ELECTRONICS FIELD CHANGE BULLETIN
NAVAL SHIP ENGINEERING CENTER, NAVY DEPARTMENT
WASHINGTON, D. C.

23-AN/URC-32
9-AN/URC-32A
14-KWT-6(8)

MODIFICATION OF FREQUENCY GENERATOR CV-731/URC
TO ACCEPT FREQUENCY CONVERTER CV-1749()/UR

PURPOSE: To modify the Frequency Generator CV-731/URC to accept the Frequency Converter CV-1749/UR. This will permit the Radio Set AN/URC-32() to be tuned in .1 KC increments.

FIGURE 1

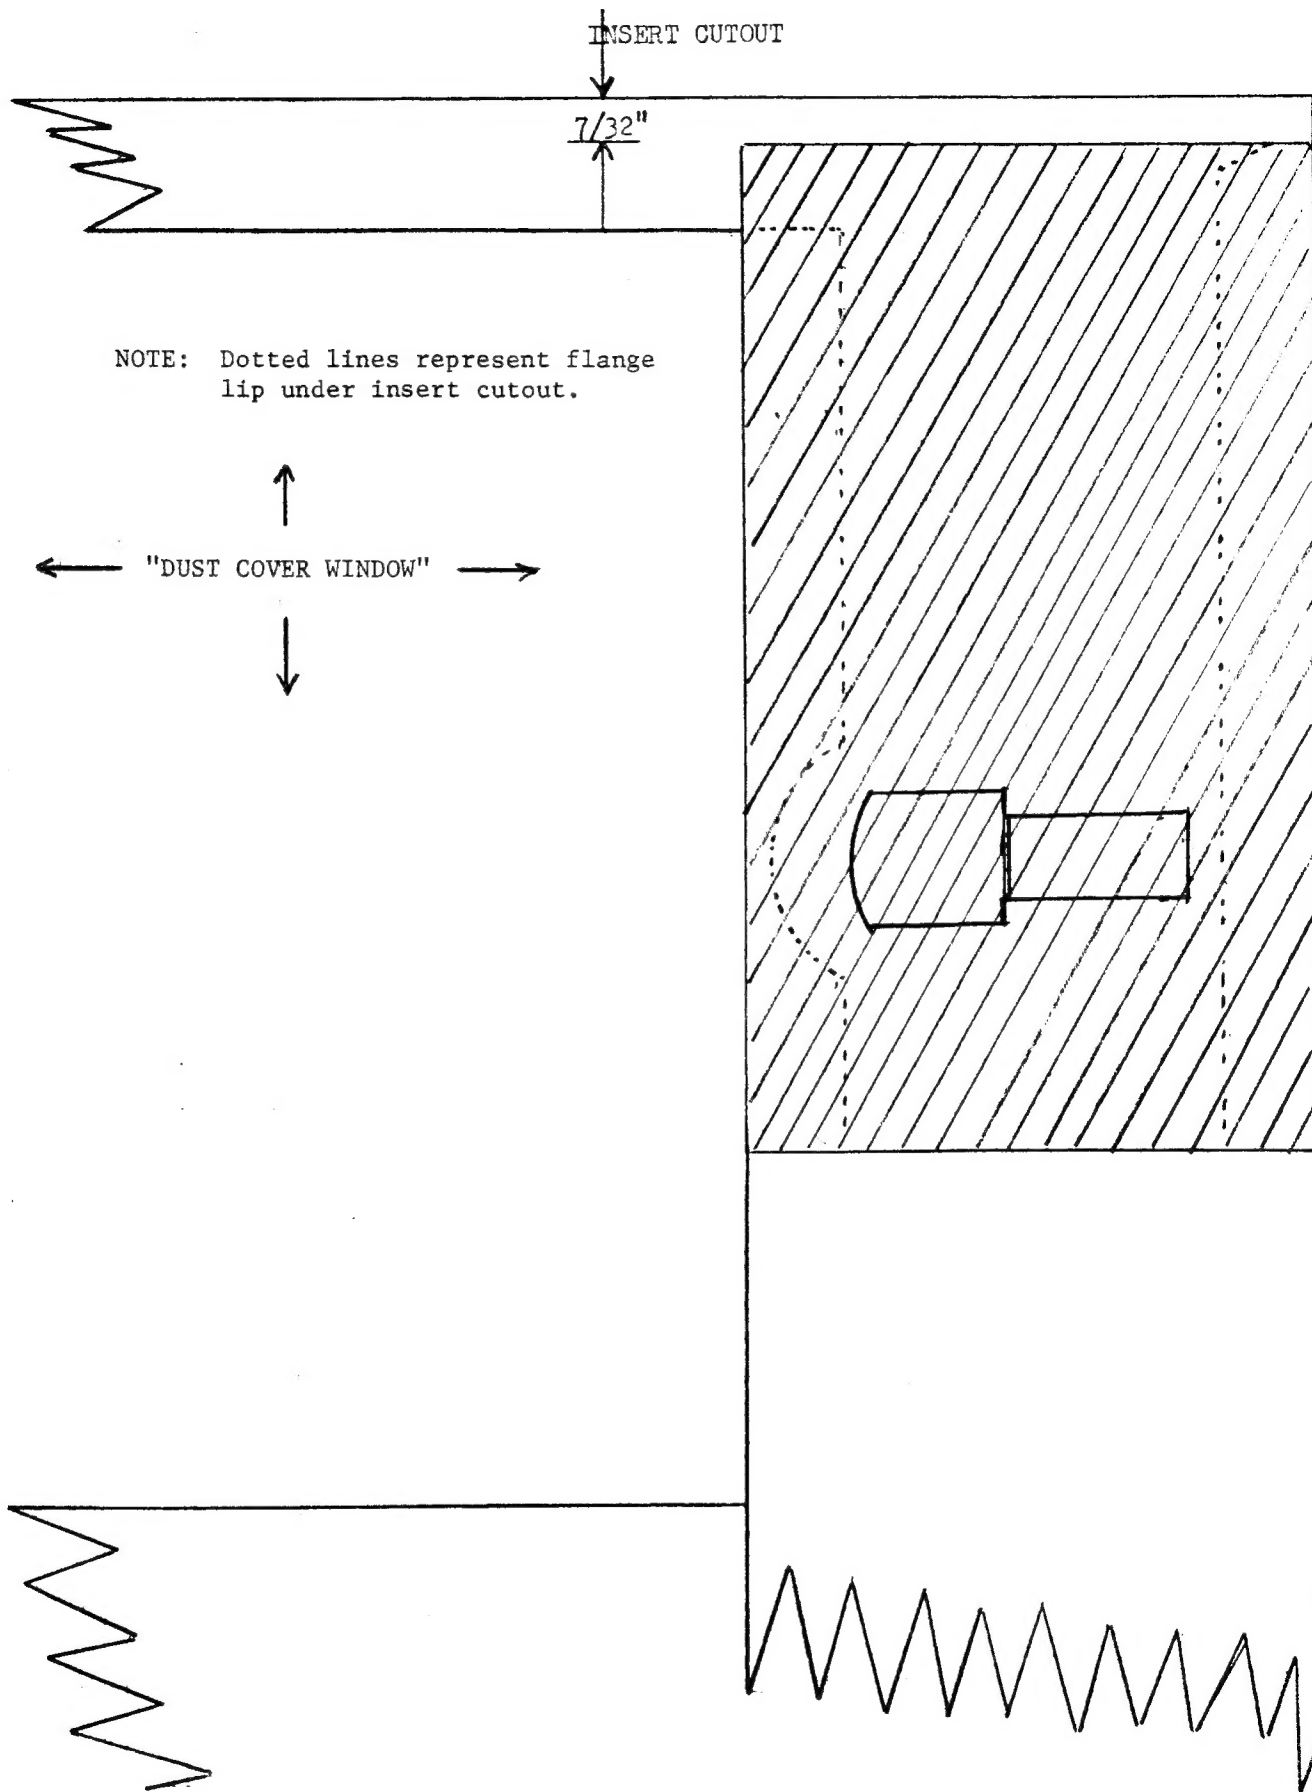
34. Place the dust cover on the work bench.
35. Refer to Figure 1. Use the combination square and scribe a line 7/32" down from the top of the right hand corner of the dust cover.
36. Place Item 5 face down on the dust cover. Use the 7/32" line scribed in Step 35 to locate the top edge of Item 5. Line up the side edges of the insert (Item 5) and scribe another line across the dust cover at the bottom of the insert (Item 5). At the right hand corner of the dust cover window, scribe a short line at the left top corner of the insert up to the 7/32" line.

37. Lay the insert (Item 5) aside and cut out the layer of metal as indicated by the diagonal lines in Figure 1. CAUTION: DO NOT CUT THE FLANGE LIPS UNDER THE CUTOUT. MAKE CUTS INSIDE THE SCRIBED LINES.

FIGURE 2
FLANGE CUTOUT

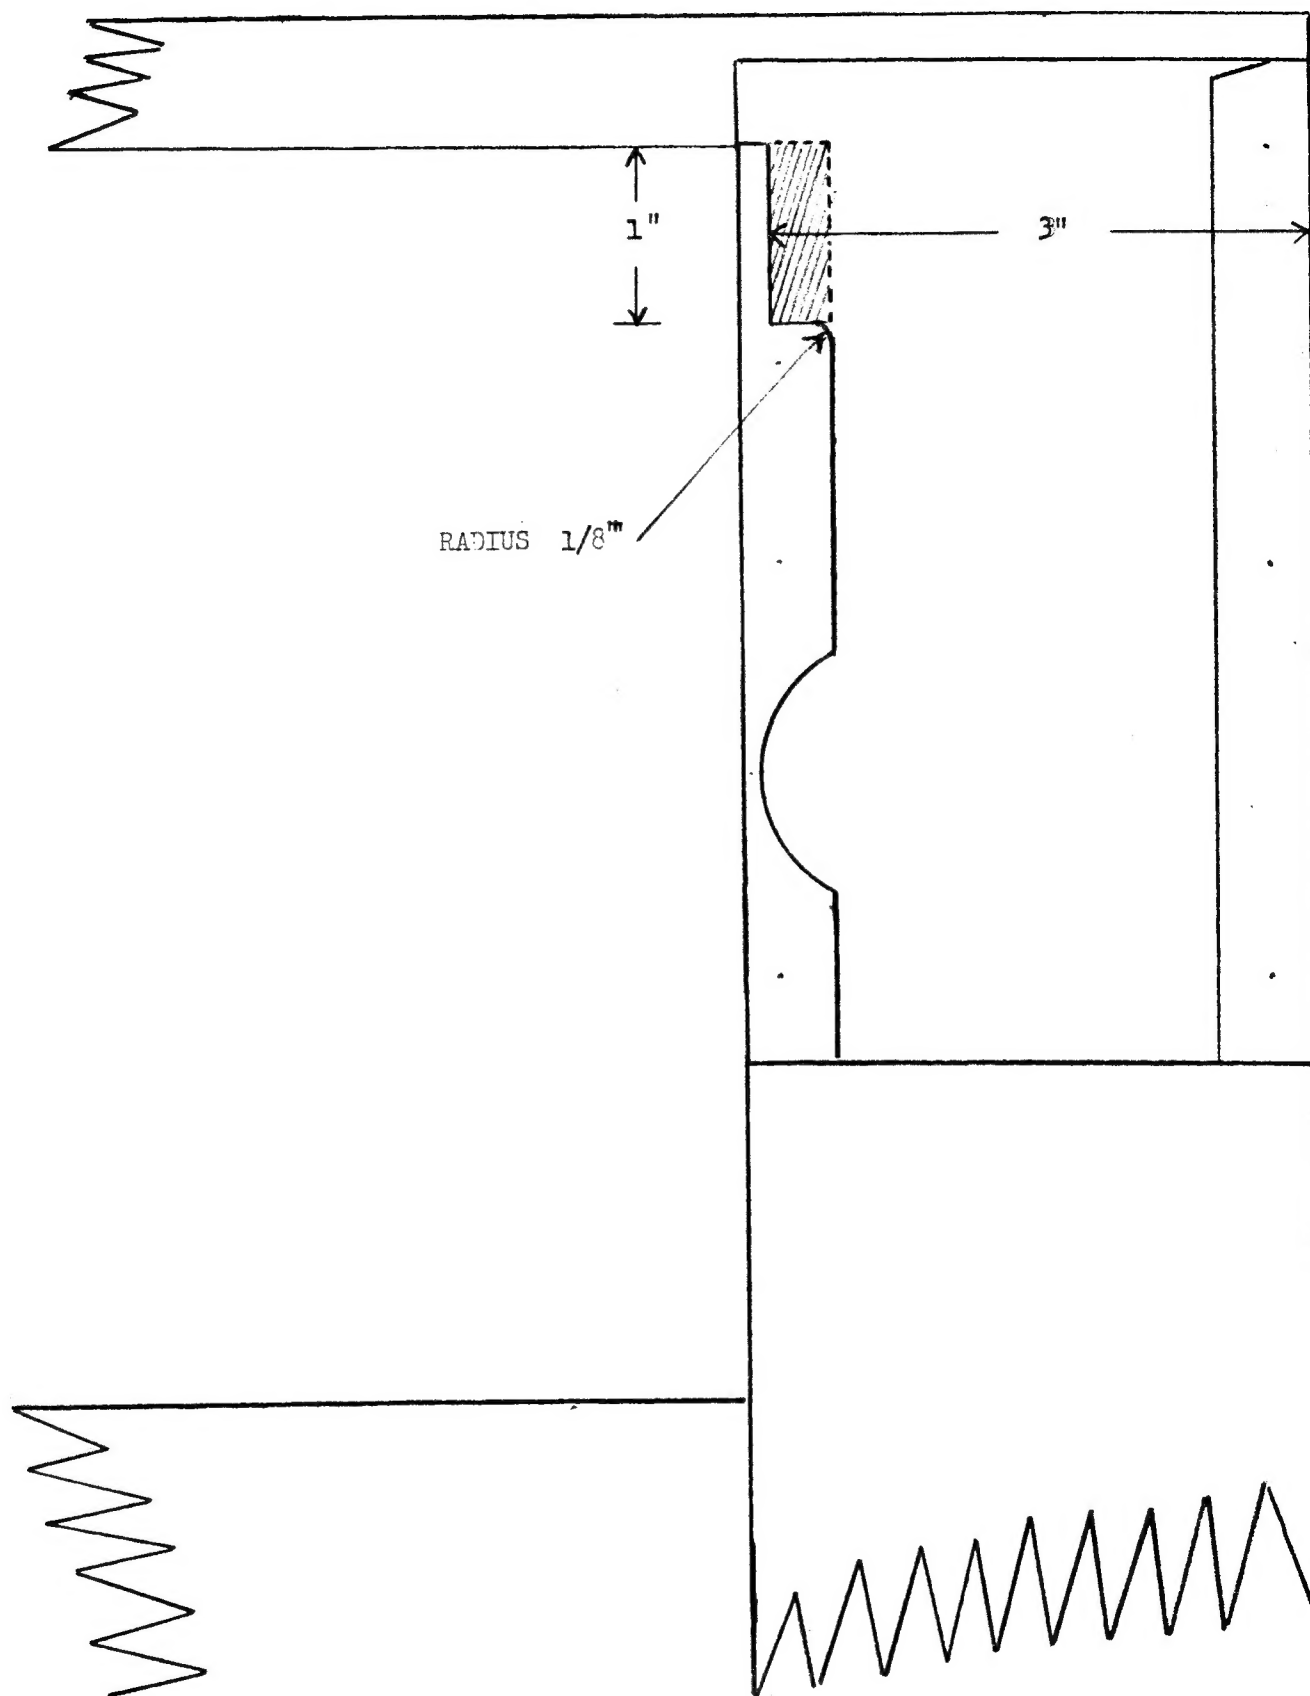
40. Make the cutout at the top of the exposed flange lip as indicated by the measurements and diagonal lines of Figure 2.

FIGURE 3

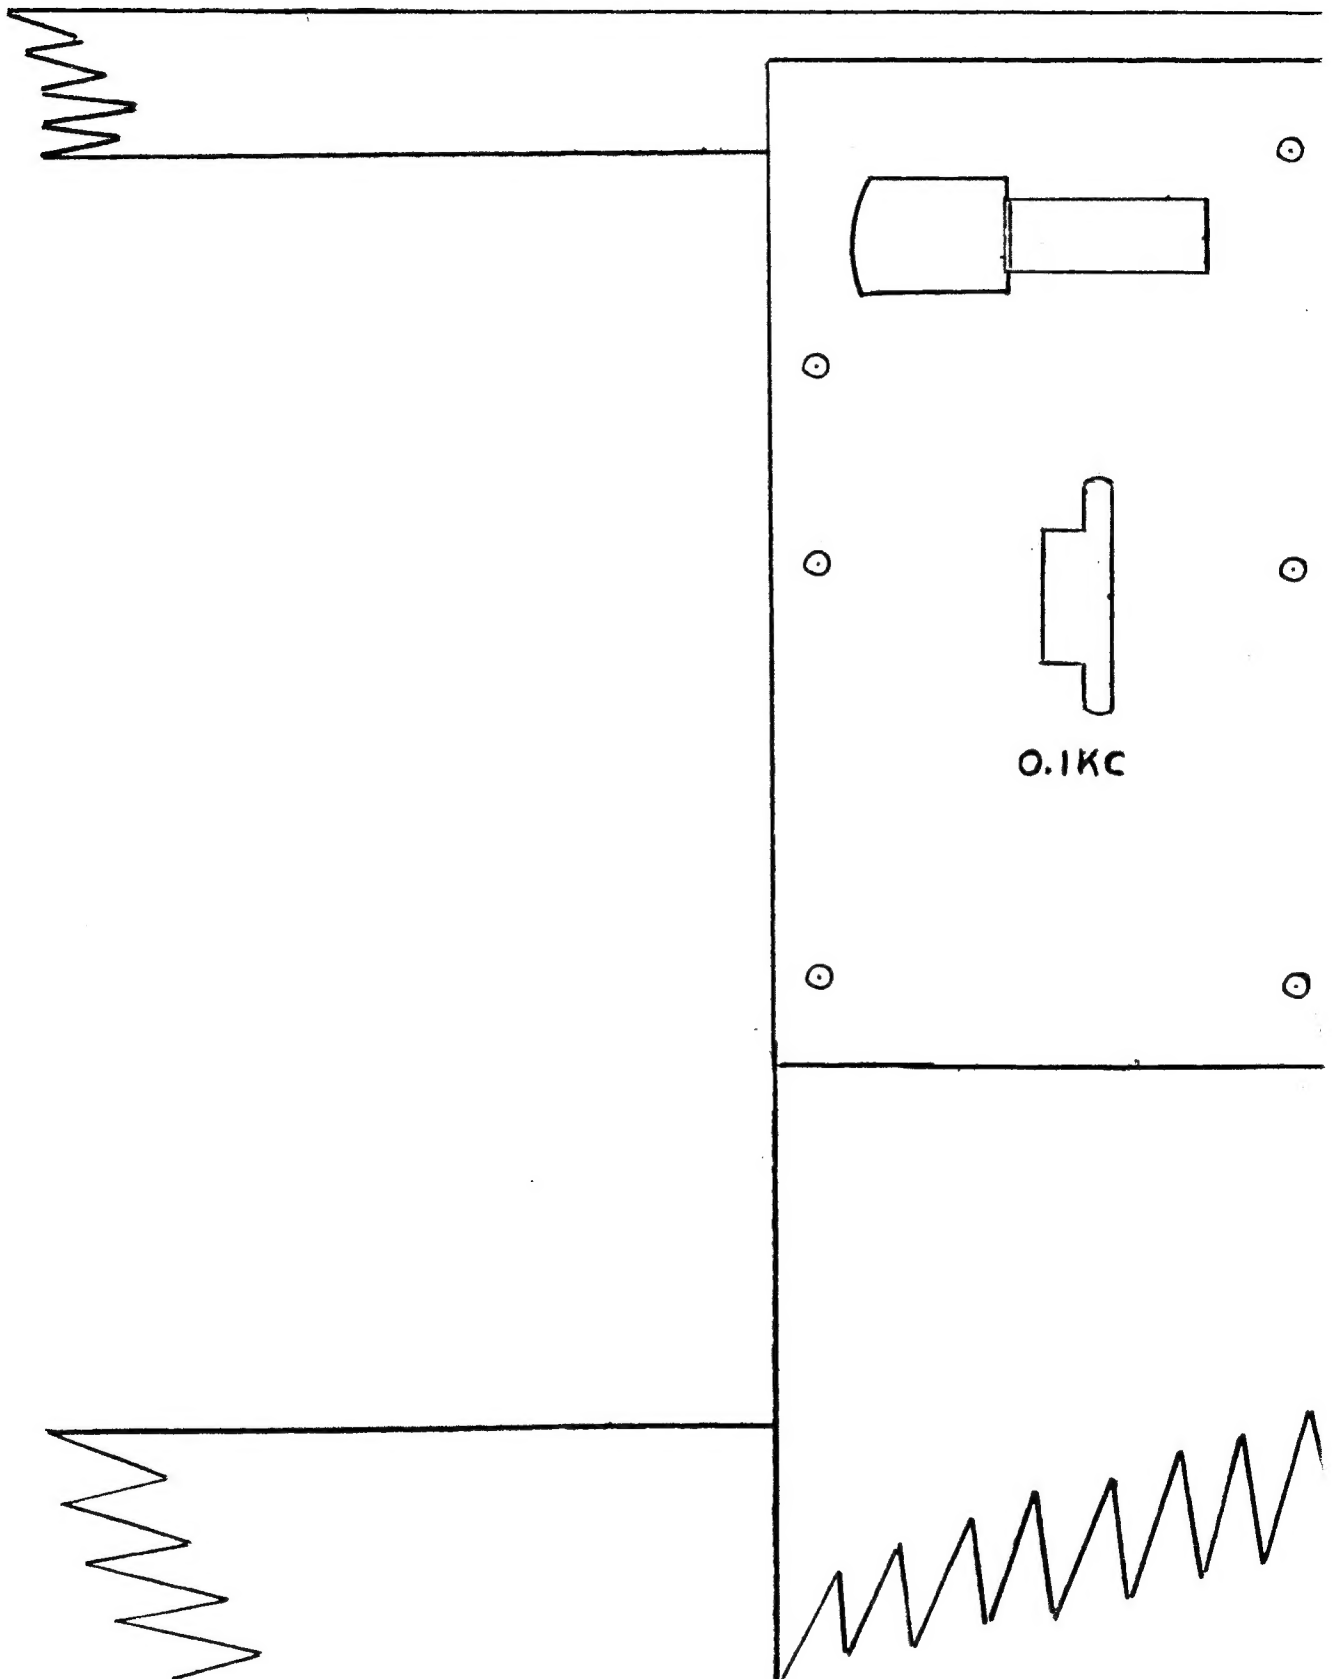
43. With the insert (Item 5) in place as shown in Figure 3 (CAUTION: THE SNAP FASTENER IS LOCATED AT THE TOP OF THE INSERT, FIGURE 3), drill the mounting holes with the #37 drill and secure the insert (Item 5) to the dust cover flanges with the rivets furnished in Item 1.

FIGURE 5
HOLE PATTERN TEMPLATE

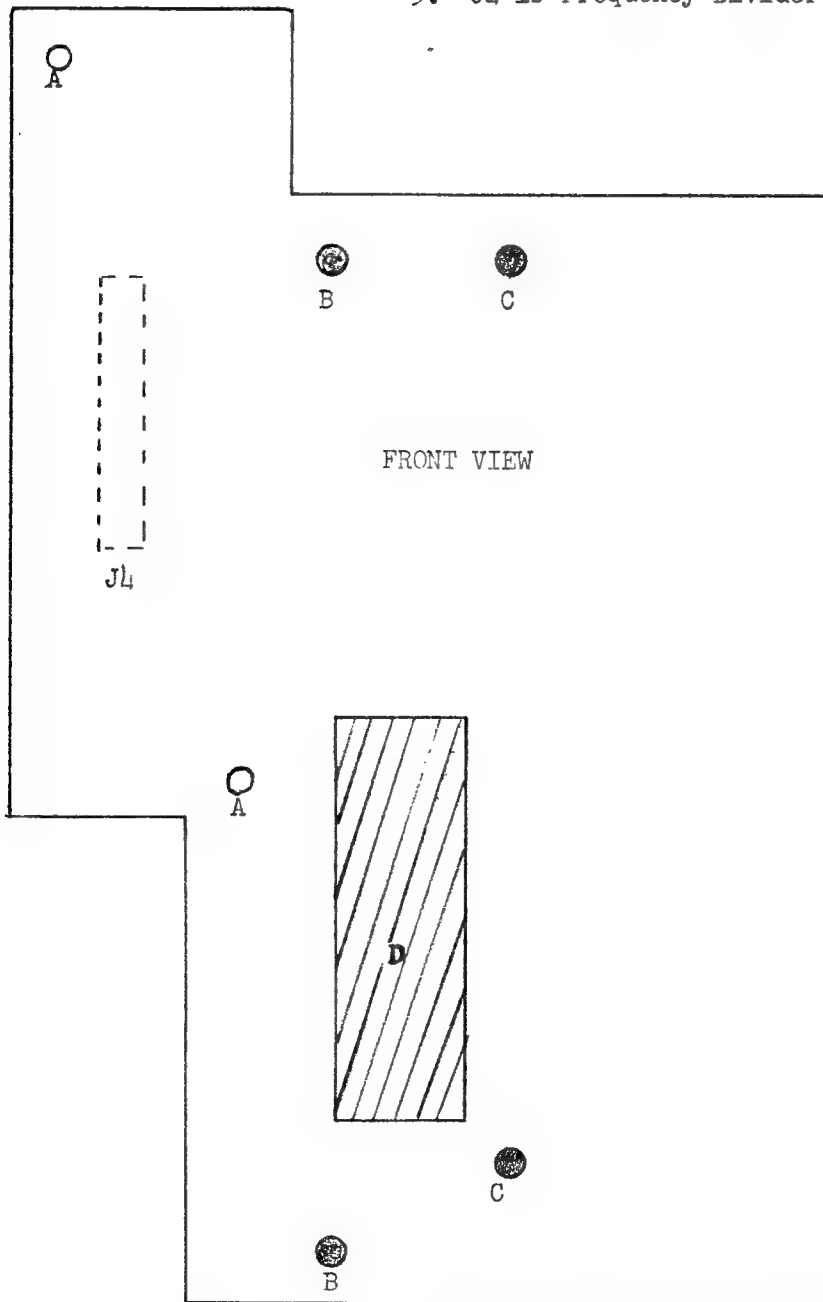
9. Refer to Figure 5. Place the template (Item 2) on the front side of the chassis so that holes "A" of the template as indicated in Figure 5 line up with the retaining screw holes for the frequency divider module.

10. Secure the template (Item 2) to the chassis, using the two 8-32 X 3/8" binder head screws (Item 6).
11. Center punch the two "B" and the two "C" holes as indicated in Figure 5. Use a #8 drill and drill the four holes.

12. Countersink the two "C" holes on the rear of the main chassis plate so that the heads of the two 8-32 flat head screws (Item 6) will be flush with the chassis.

13. Cut out rectangular hole "D" as indicated in Figure 5.

1. Secure template, item 2, using threaded retaining holes for Frequency Divider and holes A of Template
2. Drill B and C holes, using a #8 drill, in main chassis of Frequency Generator.
3. Countersink C holes from rear of chassis so that 8-32 flathead screws are flush with chassis.
4. Cutout rectangular hole D.
5. J₄ is Frequency Divider jack.

0.1KC MODULE WIRING DIAGRAM

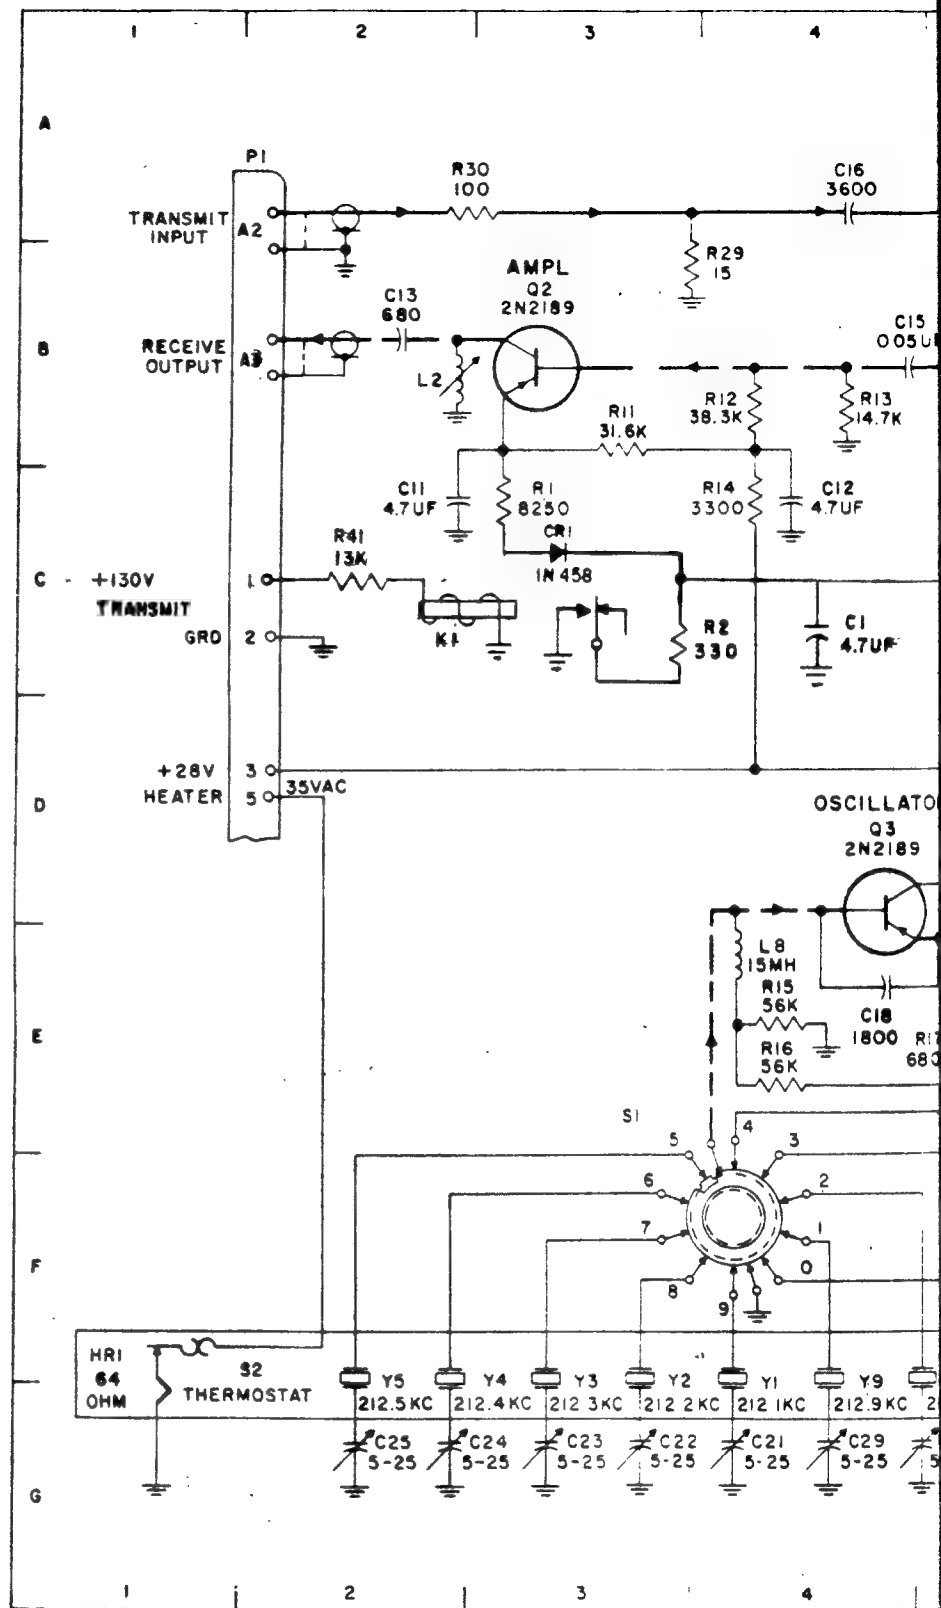
25. Refer to Figure 4 and route the leads attached to the mounting base, jack (J8) of Item 4 as follows:

From jack J8:	Lead Color:	To:
Terminal A1	White Coax	J12 (shield to J12 ground terminal)
Terminal A2	White Coax	J13 (shield to J13 ground terminal)

Terminal A3	White Coax	Center Conductor to J2-11. Shield to J2-12 ground jumper
Terminal A4	White Coax	Center Conductor to J2-8. Shield to J2-7 ground jumper
Terminal 1	Wh-Blue-Blk	C17
Terminal 2	White	Ground Lug
Terminal 3	Wh-Red-Blue	C15
Terminal 5	Wh-Red-Grn-Blk	C3

Determine lead lengths to coincide with the existing leads which made up the original cable harness. Make the soldered connections as listed above and relace the added leads with the original leads to reform the cable harness.
